ACCESSION NBR: 8709110320 DOC. DATE: 87/09/08 NOTARIZED: NO DOCKET #  
 FACIL: 50-335 St. Lucie Plant, Unit 1, Florida Power & Light Co. 05000335  
 AUTH. NAME: WOODY, C. O. AUTHOR AFFILIATION: Florida Power & Light Co.  
 RECIP. NAME: RECIPIENT AFFILIATION: Document Control Branch (Document Control Desk)

SUBJECT: Forwards partial response to EG Tourigny 870716 request for addl info re 870612 application for amend to license. Util will respond to certain portions of request in near future. Phased response acceptable by NRC.  
*SEE @ DRAWINGS*

Re: St. Lucie Unit I  
Docket No. 50-335  
Spent Fuel Rerack

FIGURE 1

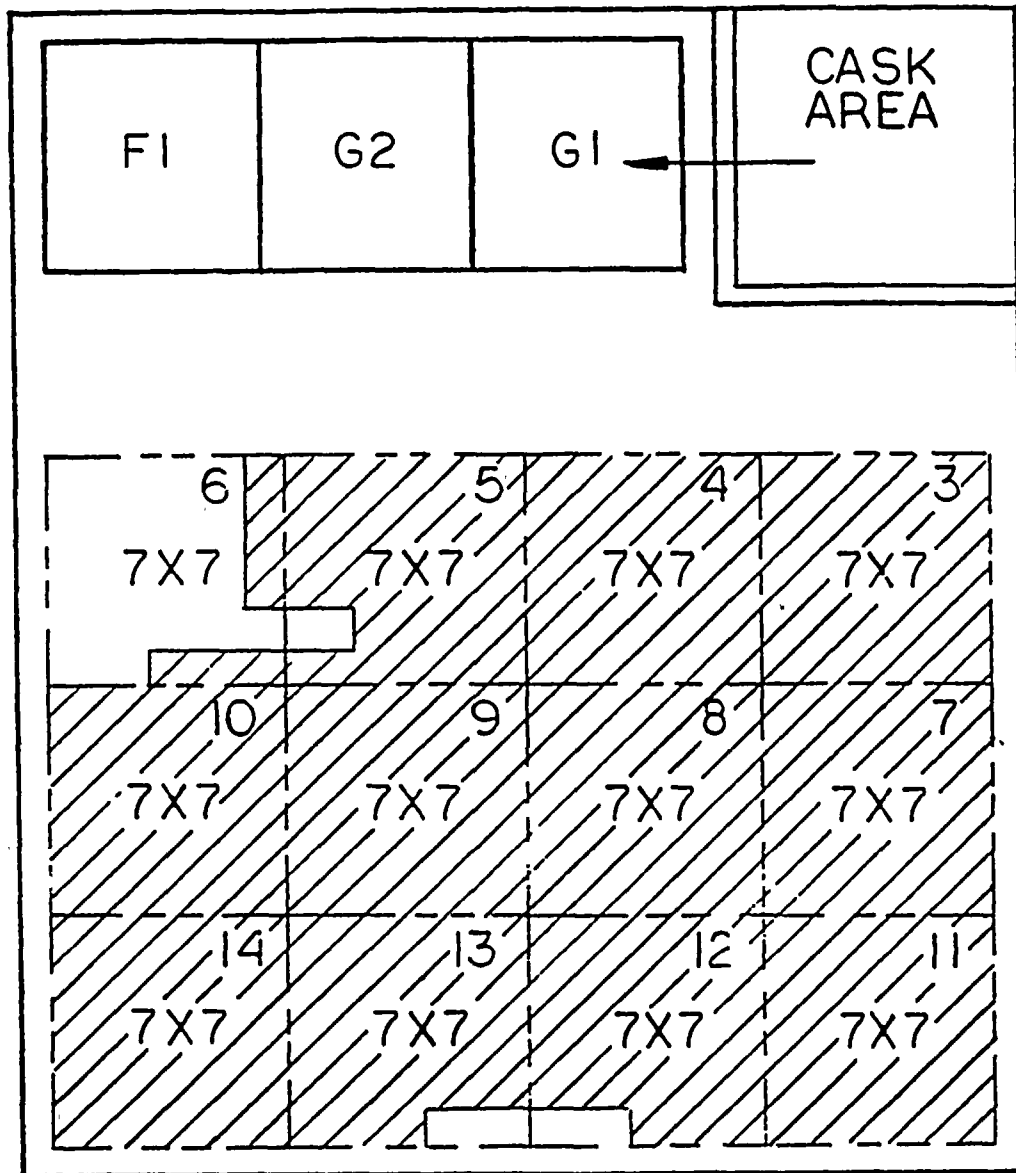
1. Following the removal plan (see question #5), remove Racks 1 and 2 from the pool as shown in Figure #1.
2. Following the installation plan (see question #5), install Racks F1-G2-G1 as shown in Figure #2.

FIGURE 3

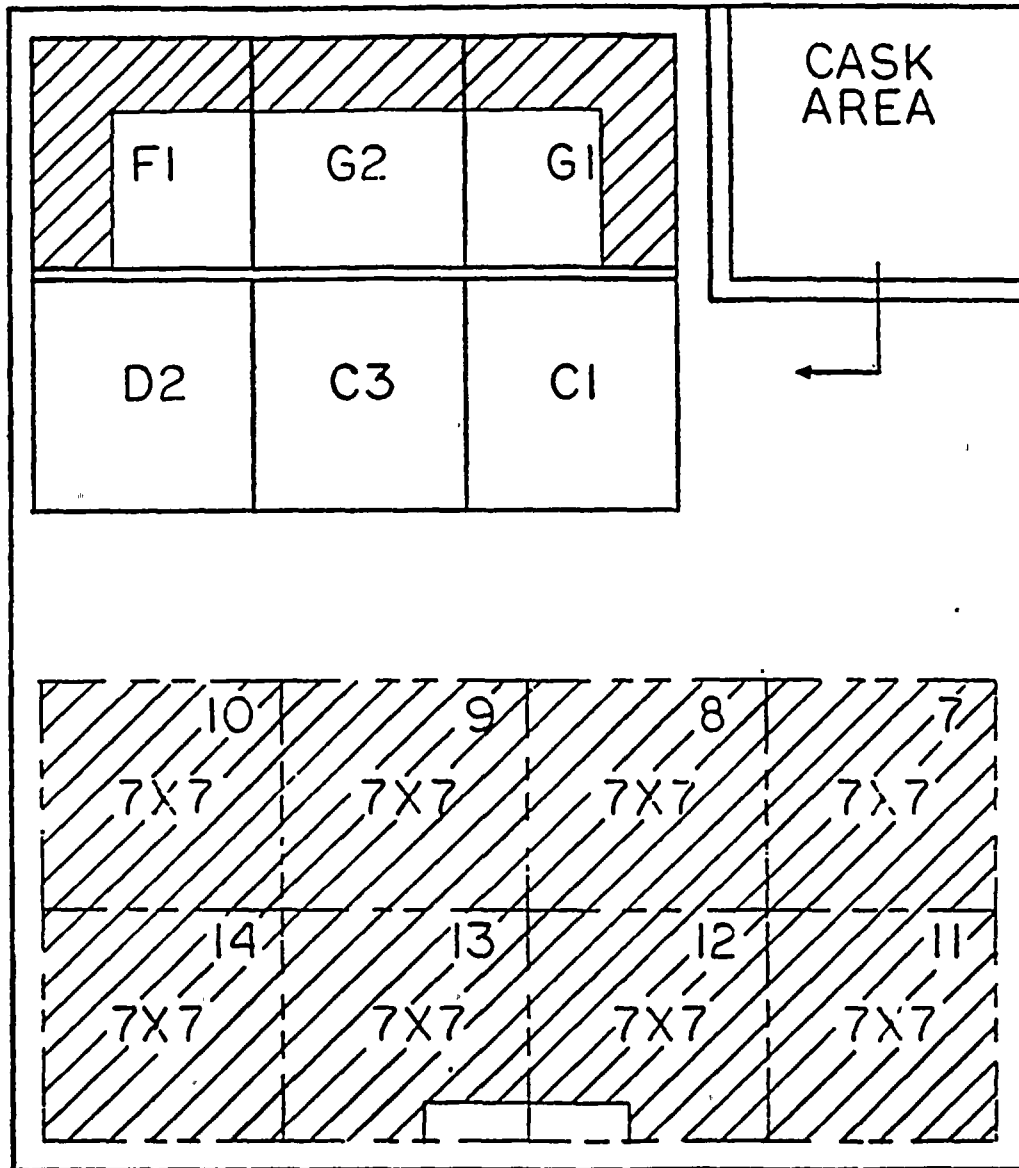
3. Relocate all of the 238 fuel assemblies stored in Rows "L through T" to new racks F1-G2-G1 as shown in Figure #3.
4. Following the removal plan (see question #5), remove all four racks, which are in Rows "L through T", removing 3, 4, 5 and 6 shown in Figure #3.

FIGURE 4

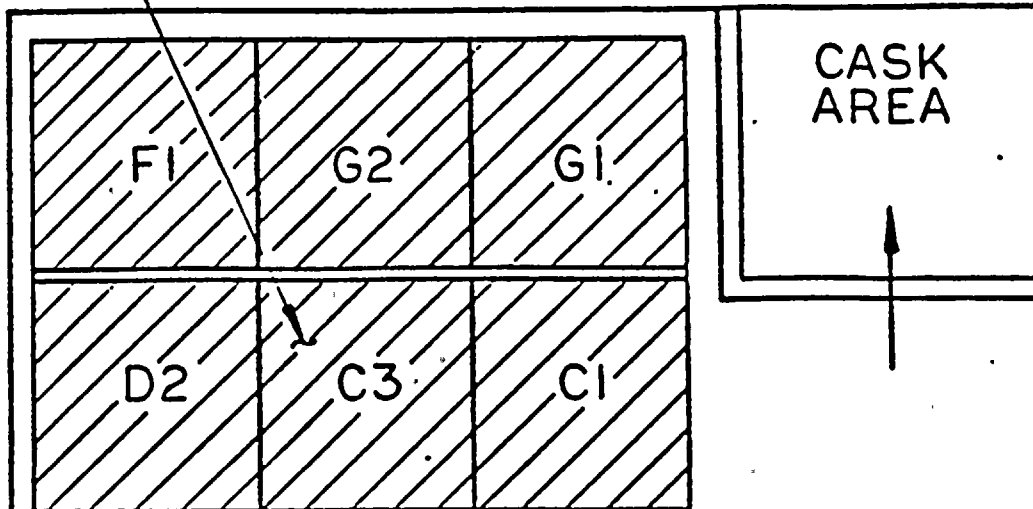
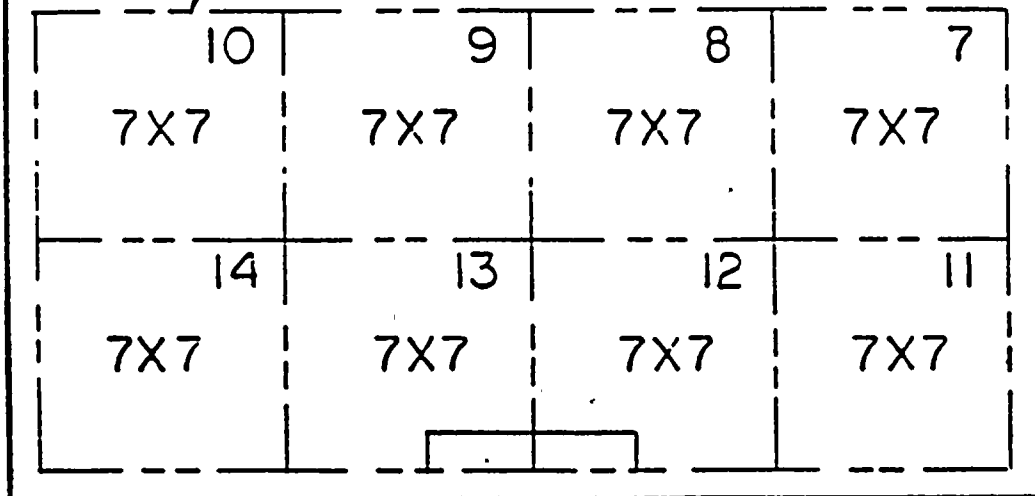
5. Following the installation plan (see question #5), install new Racks D2, C3, C1, as shown in Figure #4.
6. Relocate all the assemblies stored in old racks into new racks as shown in Figure #5.

FIGURE 5

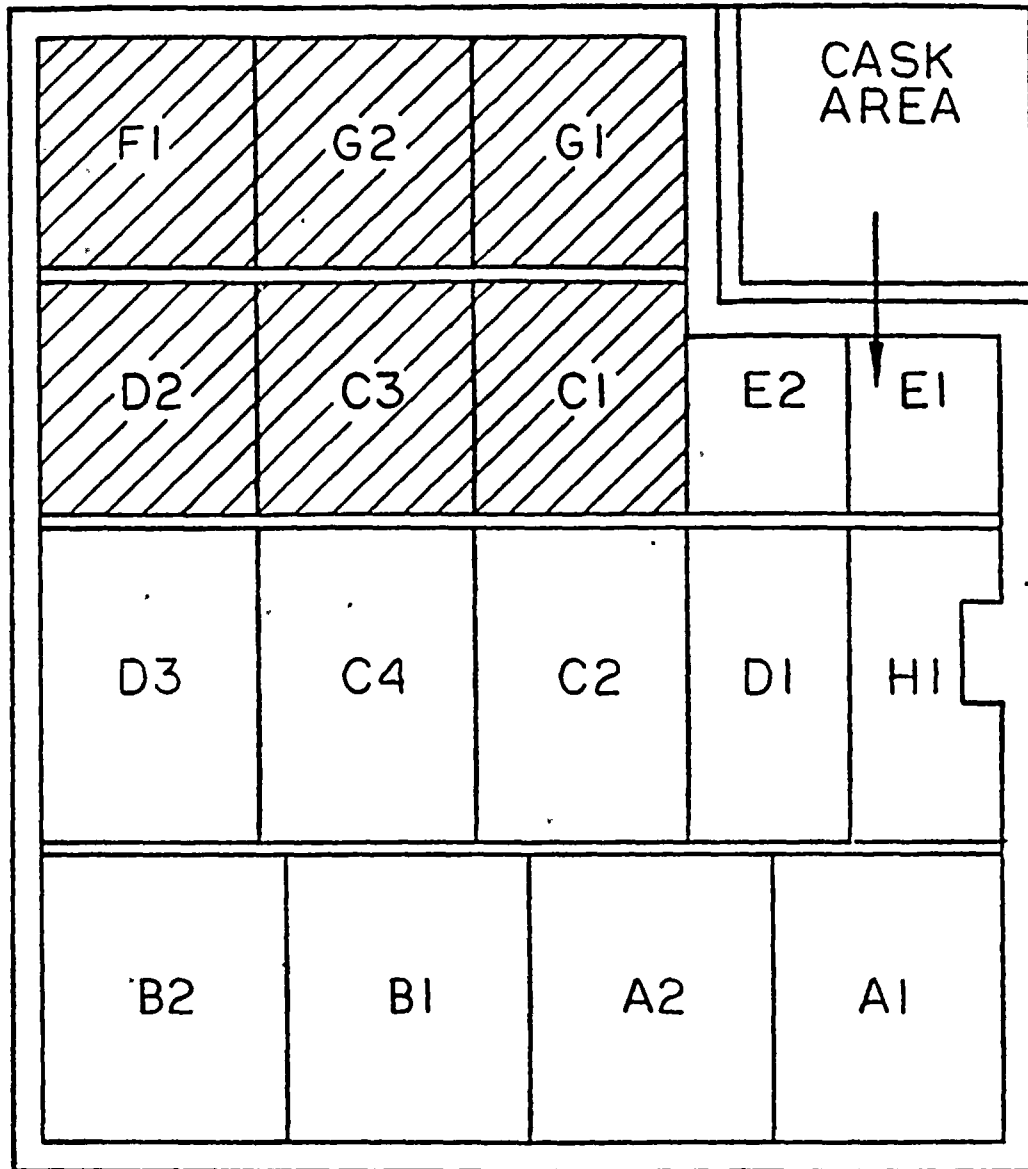
7. Following the removal plan (see question #5), remove all eight Racks 7, 8, 9, 10, 11, 12, 13 and 14 shown in Figure #5.
8. Following the installation plan (see question #5), install new Racks D3, B2, C4, B1, C2, A2, A1, D1, H1, E2 and E1 shown in Figure #6.

|     |      |    |          | 1 9/16/87 RW |      |    |          | CH                           |  |  |  | FUEL HANDLING BUILDING PLAN |  |

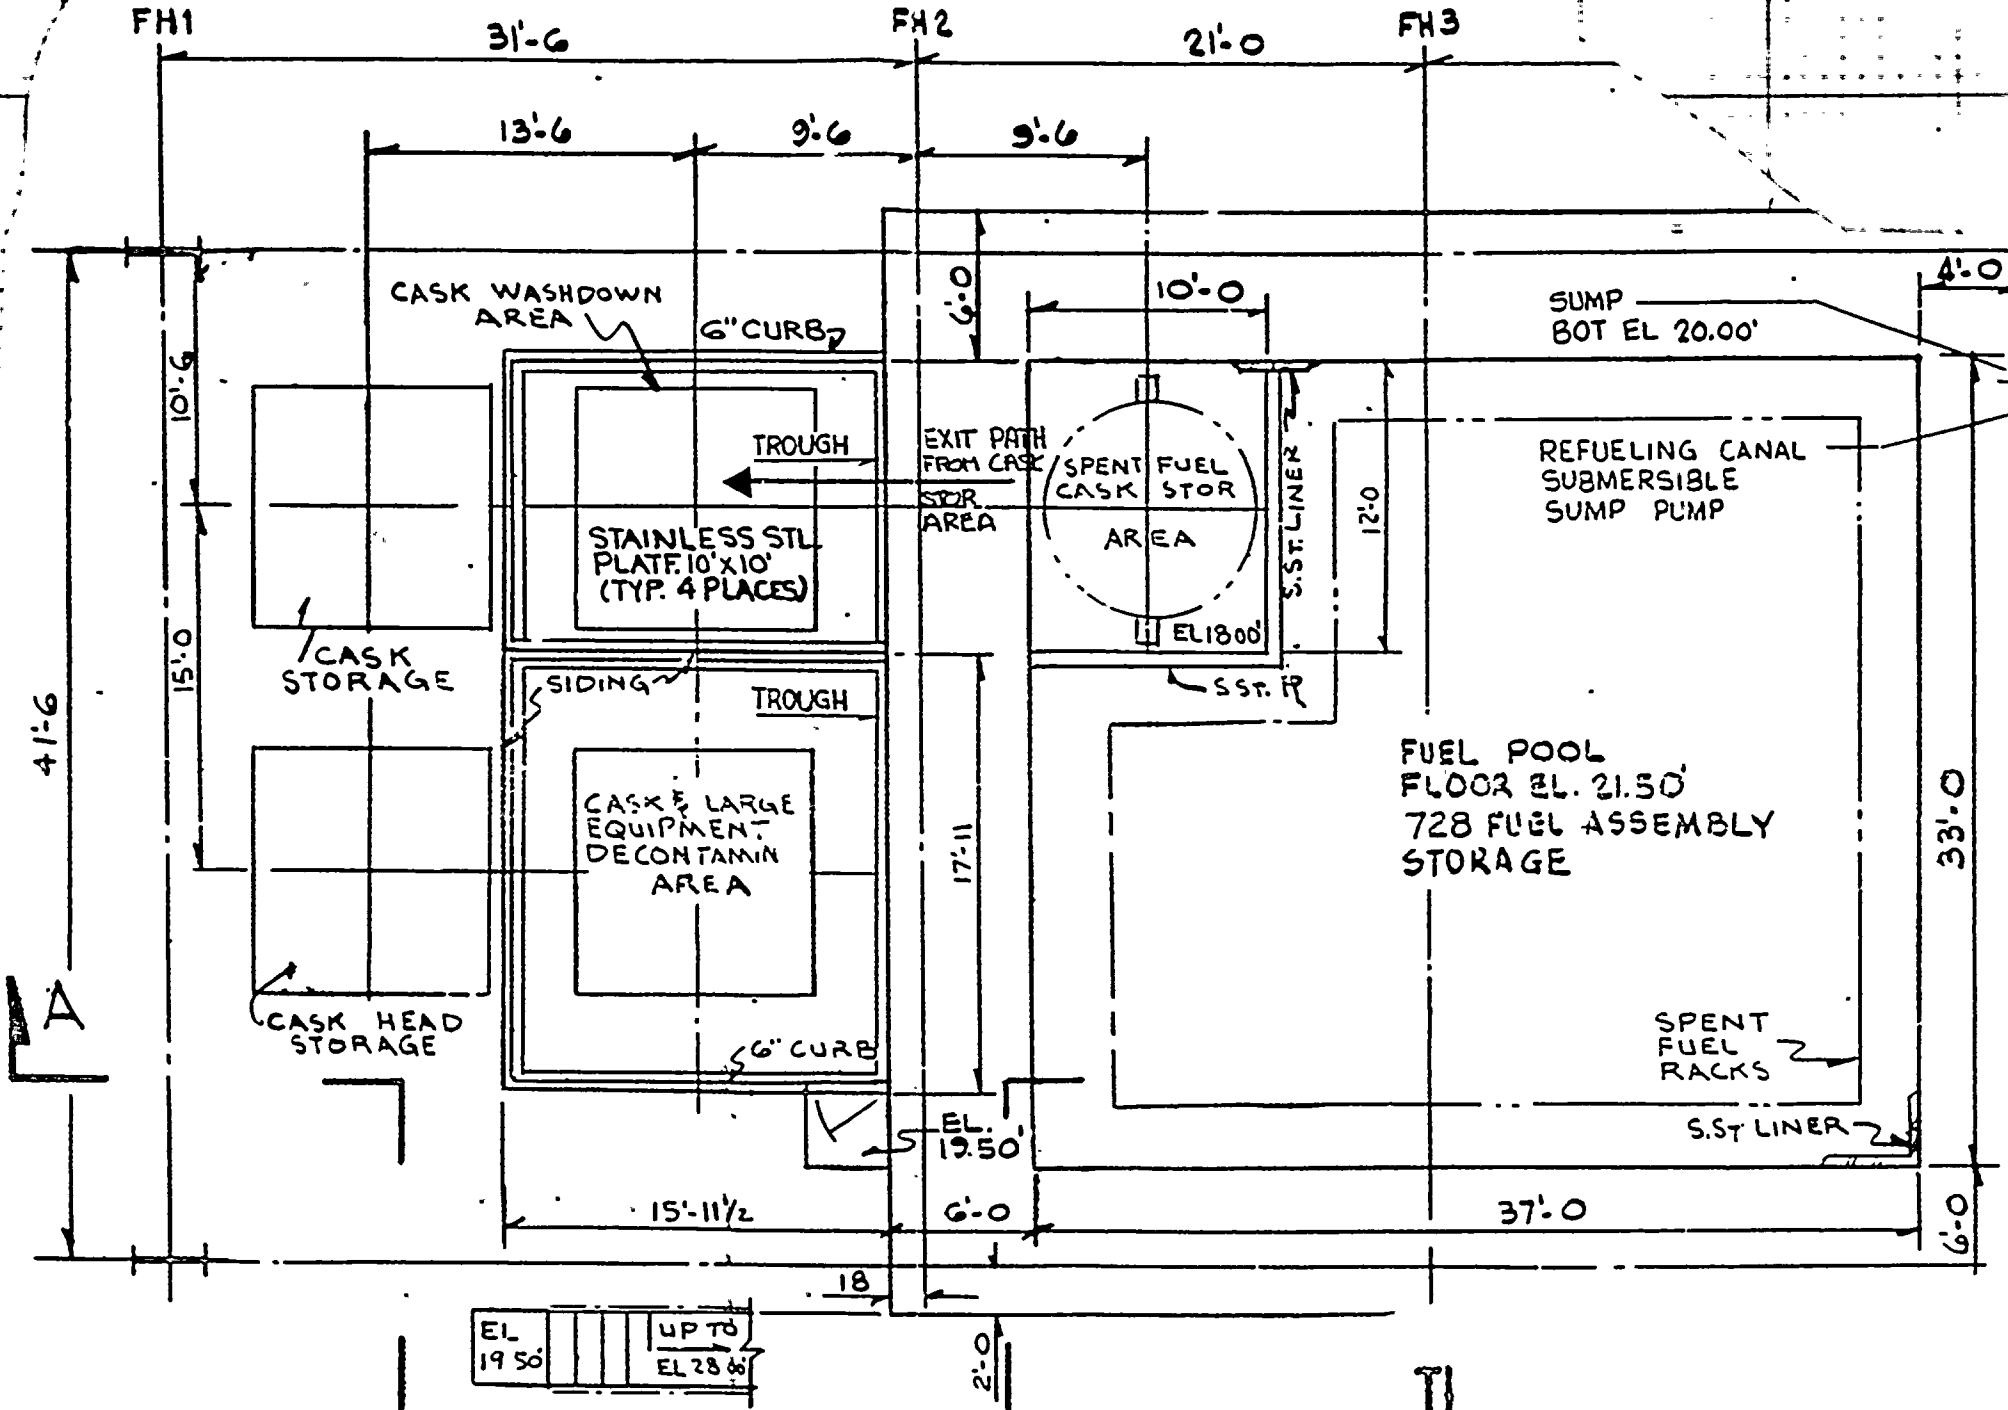
QUESTION: Provide drawings which show the movement of both the existing and the new racks throughout their entire path of travel from outside of the fuel handling building until their final location in the spent fuel pool (and the reverse for the existing racks).

RESPONSE: For the removal of the racks from the spent fuel pool cask storage area to outside the spent fuel pool (see General Arrangement sketch SK-83-02-M-001 attached) each rack module will be removed individually following a path that does not carry the rack over any other racks containing spent fuel (see response to question number 6). Each rack module will be removed by crane and transported over a prescribed path to the spent fuel cask storage area. The old racks will be washed down and dried. The dried racks will then be placed in polyethylene bags and removed to the cask equipment decontamination area. The polyethylene bags will be removed and discarded and the racks will be cleaned until desired results are achieved. The racks will be inserted in clean polyethylene bags and moved to a designated rack storage area on site.

For installation of the new spent fuel racks the racks will be brought from their onsite storage location to the cask washdown area and cleaned as required. After cleaning is complete each rack module will be transported into the spent fuel cask storage area. From the spent fuel cask storage area the module will be transported over the spent fuel pool (see response to number 6) to its proper location, where it will be placed. During the process the racks will not be carried over racks containing spent fuel.
